RE: 2101 RIMCREST DRIVE ADMINISTRATIVE DESIGN REVIEW CASE NO. PADR-002506-2023

DESIGN REVIEW STAFF REPORT - HILLSIDE SINGLE FAMILY

Façade remodel and architectural style change of an existing 6,268 square-foot, three-story single-family residence, originally built in 1986 with an existing attached three-car garage on a 42,689 square-foot lot, located in the R1R-II zone (Restricted Residential - Floor Area Ratio II). The project includes a new 433 square-foot balcony at the front and window and door replacements throughout the house.

PROPOSED SOUTH ELEVATION

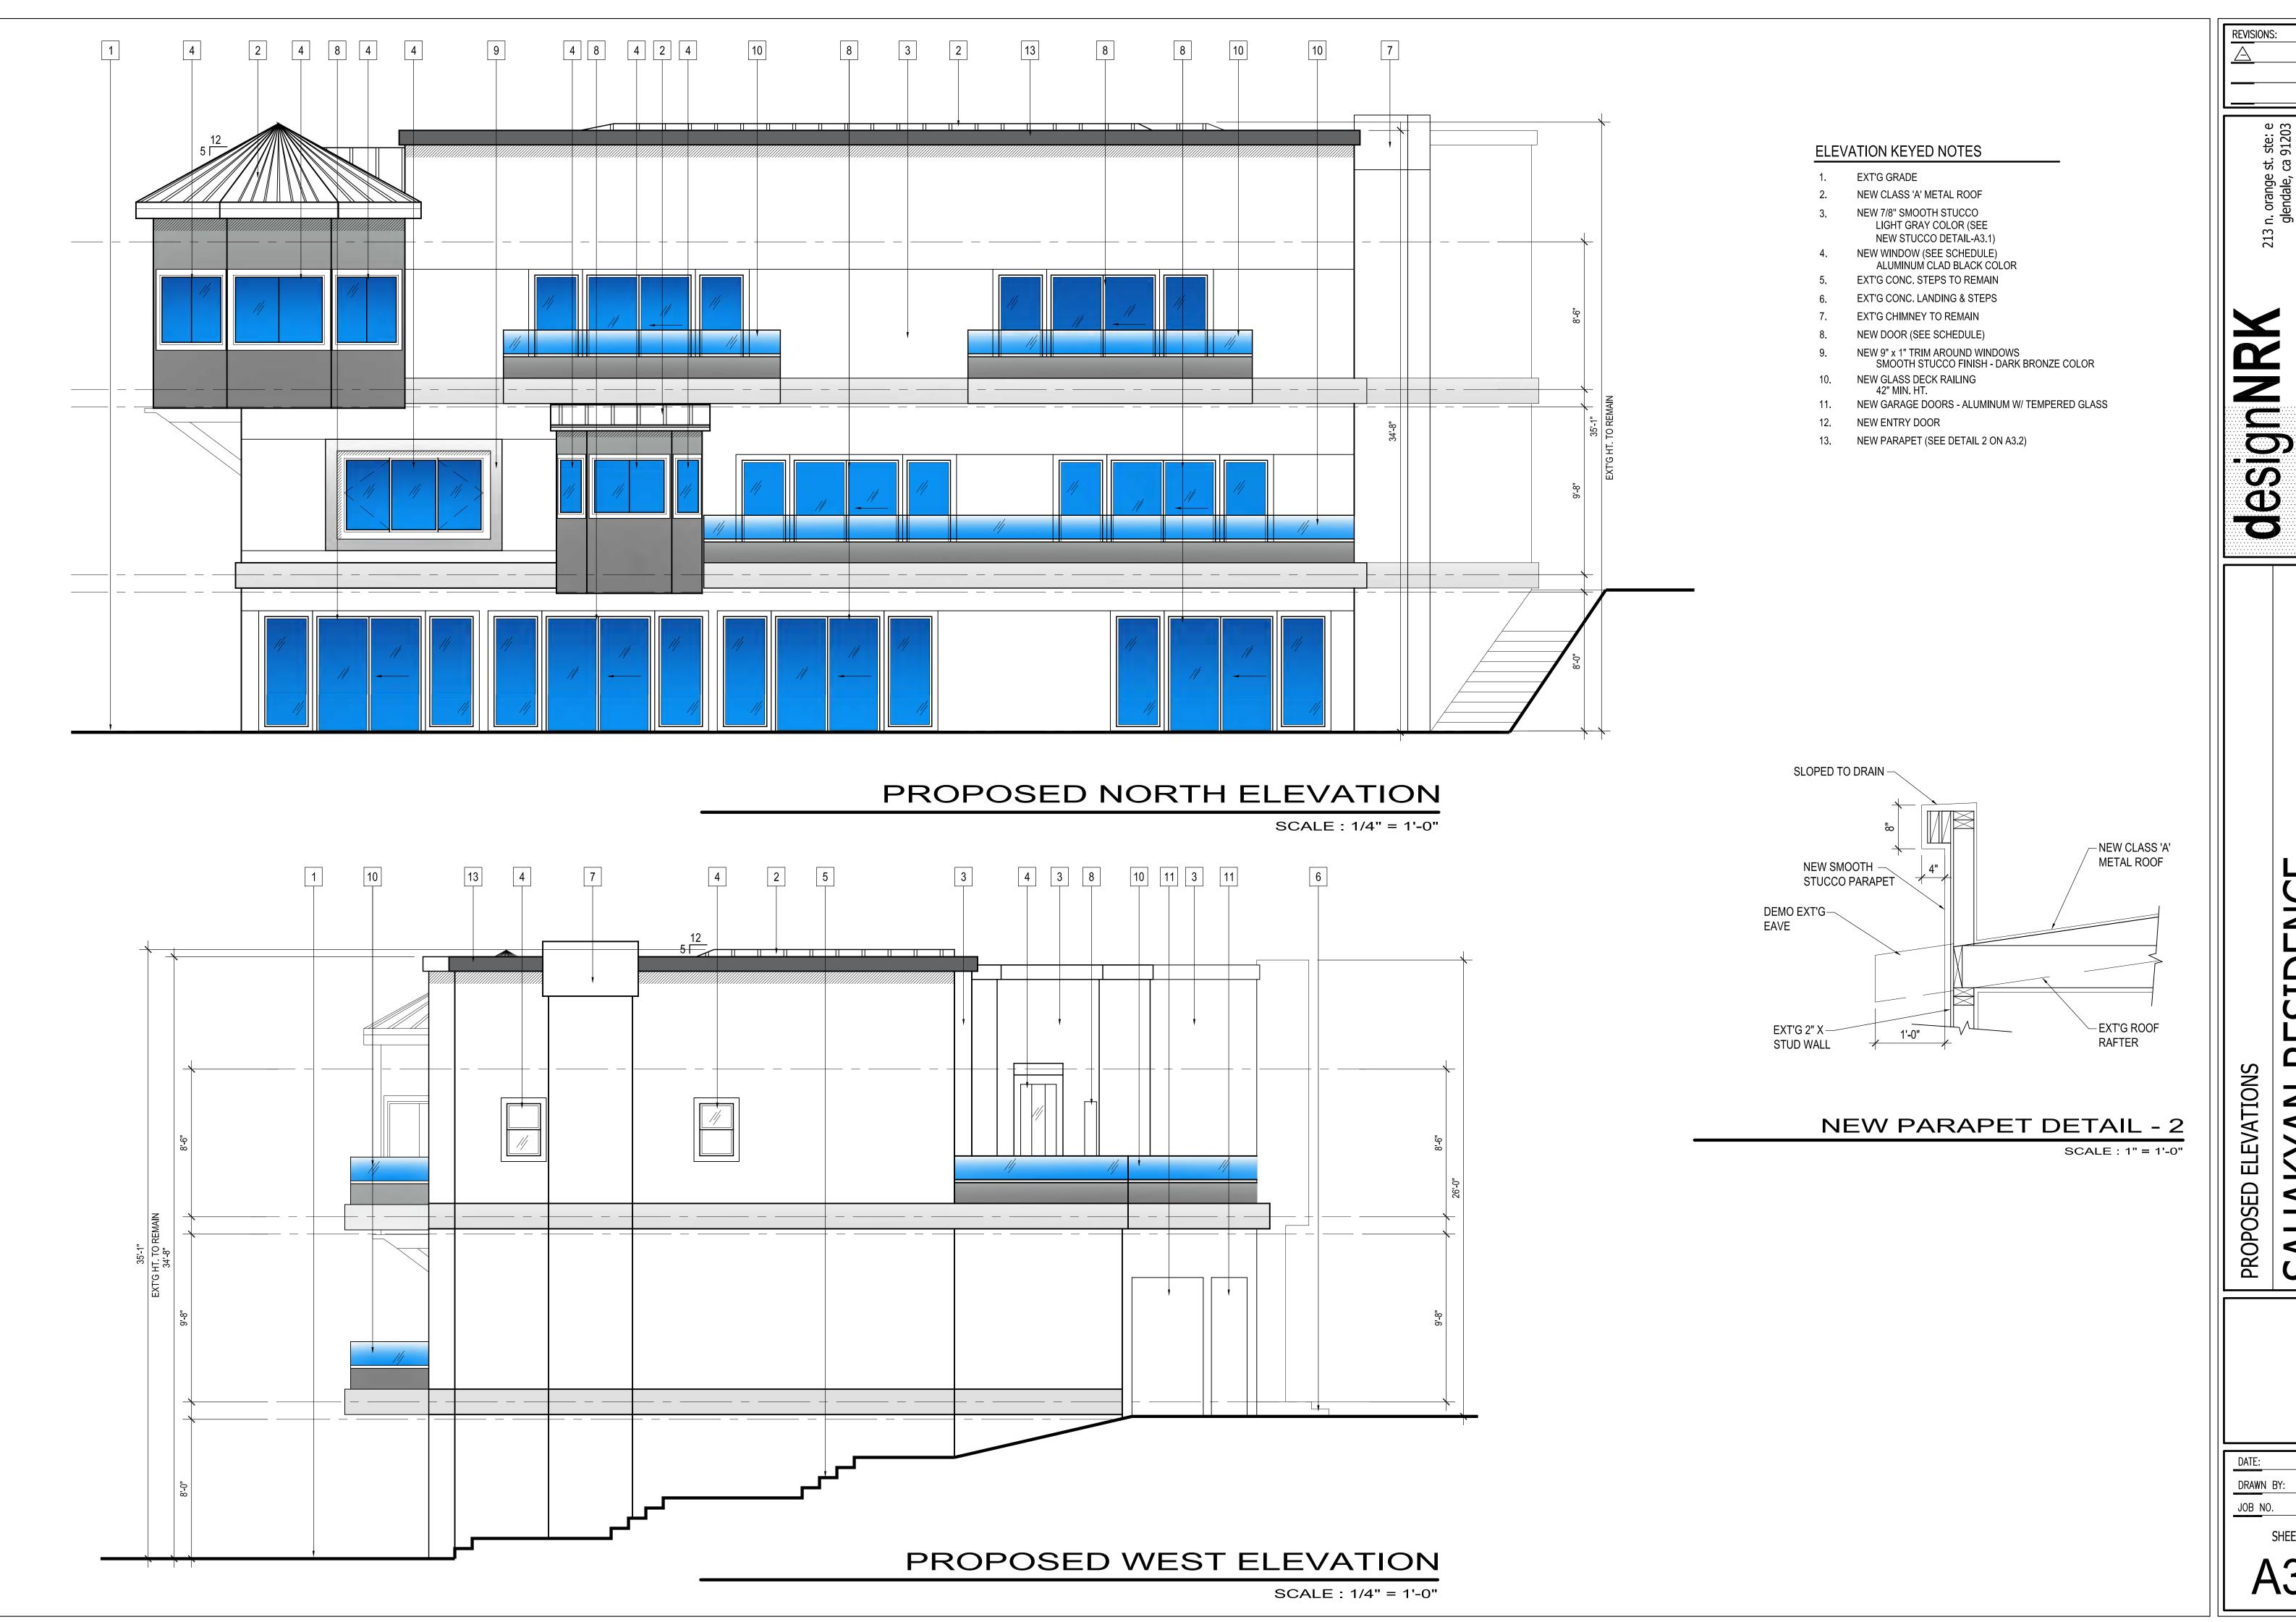
Overall, the proposed façade remodel, architectural style change, new balcony, and new doors and windows are consistent with the existing building's scale and its surrounding context. A condition of approval is added to enlarge and adjust the size the new single balcony door to be proportioned in relation to the scale and size of other new doors and windows.

- 1. Enlarge and adjust the size the new single balcony door (front façade) to be proportioned in relation to the scale and size of other new doors and windows.
- 2. Update plans to show the design and location of any exterior light fixtures, appropriate to the design and remodel. The light fixture must avoid spillover and over-lit facades.
- 3. Provide a vertical window section drawing to show the placement of the window frame within the exterior walls, appropriate to the overall design and remodel.
